# **SITE INSPECTION REPORT ON THE PROPOSED TEESTA IV DAM**

Submitted to the Standing Committee of the National Board for Wildlife

August 2013

**Figure 3: Location of hydroelectric dams mentioned in this site inspection report in relation to the Supreme Court mandated 10-km eco-sensitive area (shown in beige) around National Parks and Wildlife Sanctuaries (shown in green) in Sikkim State. (Map layers, courtesy of WWF-India)**

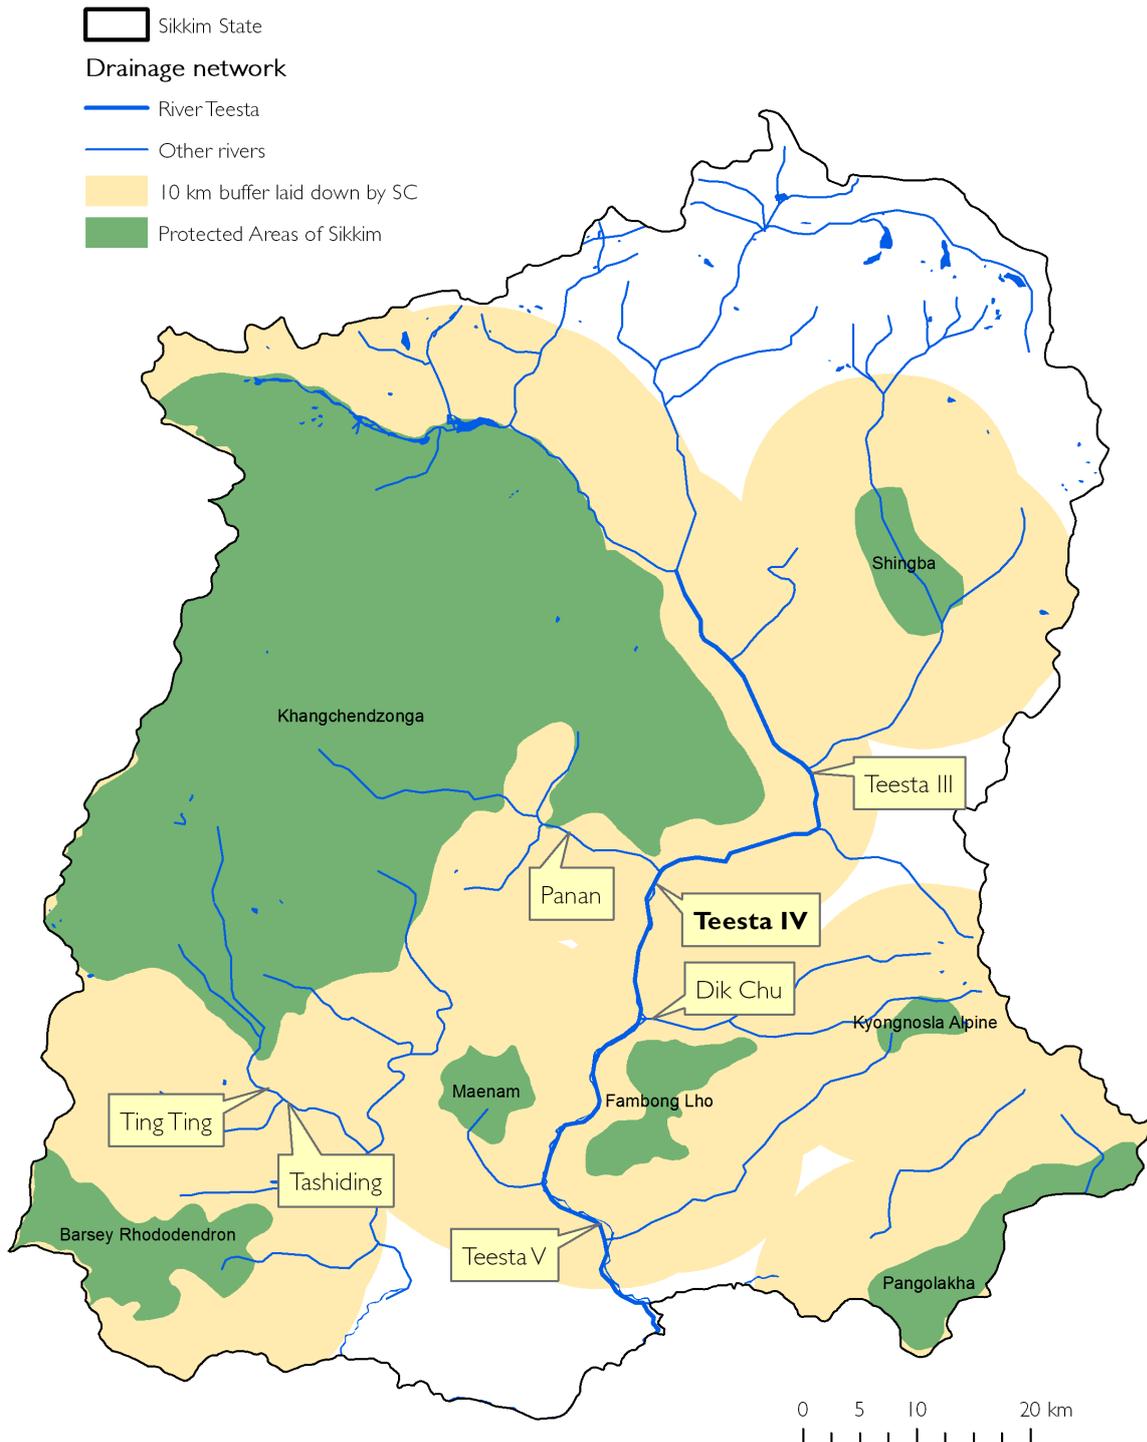
Both before and during our site inspection, multiple stakeholders brought to our notice that there were other proposed and ongoing hydel projects in the Teesta Basin located within the eco-sensitive zone (as defined by the Supreme Court in the Goa Foundation case), of the Khangchendzonga NP and Fambonglho WLS, which had **not** obtained the Supreme Court mandated clearance from the Standing Committee of the National Board for Wildlife. Besides this, we had ourselves seen two projects under active construction—the Dik Chu and the Teesta III—that were clearly within the Supreme Court mandated eco-sensitive area, for which FEWMD officials had no knowledge of clearances having been obtained from the Standing Committee of the National Board for Wildlife.

We were, therefore, left with no option but to use publicly available information on Environmental Clearances (EC) (<http://environmentclearance.nic.in>), submissions and information provided by other stakeholders, and to examine minutes from the Standing Committee of the National Board for Wildlife's meetings, to ascertain if there was merit to the allegations made about the violations of the Supreme Court's order of 12/2006. Based on the above sources of information available to us, the names of projects mentioned by stakeholders, their locations (see Figure 3) and their compliance status, are provided below:

- c) Based on the information we have been able to gather, it appears to be unfortunately true that there are several hydroelectric projects in various stages of implementation within the Supreme Court mandated 10-km eco-sensitive zone around Sikkim's national parks and wildlife sanctuaries, that have not sought and obtained the mandatory clearance of the Standing Committee of the National Board for Wildlife. We were witness to the ongoing construction of two such projects—Dik Chu and Teesta III—which fall within the eco-sensitive zone of Khangchendzonga NP and Fambonglho WLS.
